DEPARTMENT OF TRANSPORTATION**Federal Railroad Administration****49 CFR Parts 216 and 238**

Passenger Equipment Safety Standards

ACTION: Final rule; response to petitions for reconsideration.

SUMMARY: This document responds to certain of the petitions for reconsideration of FRA's May 12, 1999 final rule establishing comprehensive Federal safety standards for railroad passenger equipment. This document clarifies and amends the final rule.

Figure 2

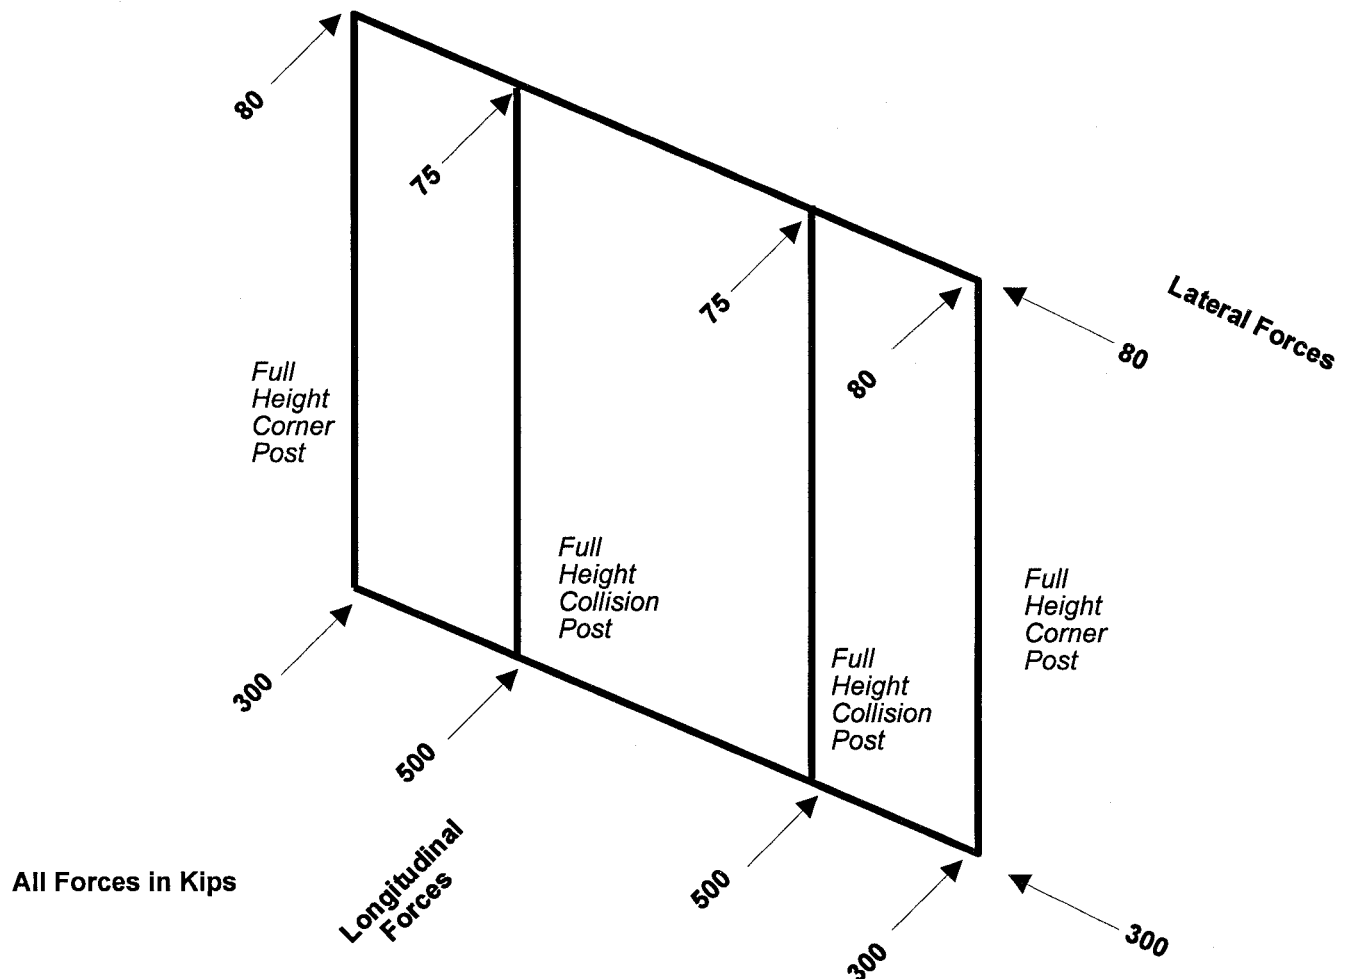
FRA has adopted Bombardier's request and modified paragraph (b)(1) accordingly. (FRA has also made a

corresponding change to figure 2 to subpart E.) FRA recognizes that the strength of the power car cab's rear collision posts should not necessarily be dependent on the strength of the cab's front end structure, as the front and rear end structures are intended to protect against somewhat different hazards. The front end structure must protect against the greater hazard of a head-on collision with another train or object.

30. Figure 2 to subpart E is revised to read as follows:
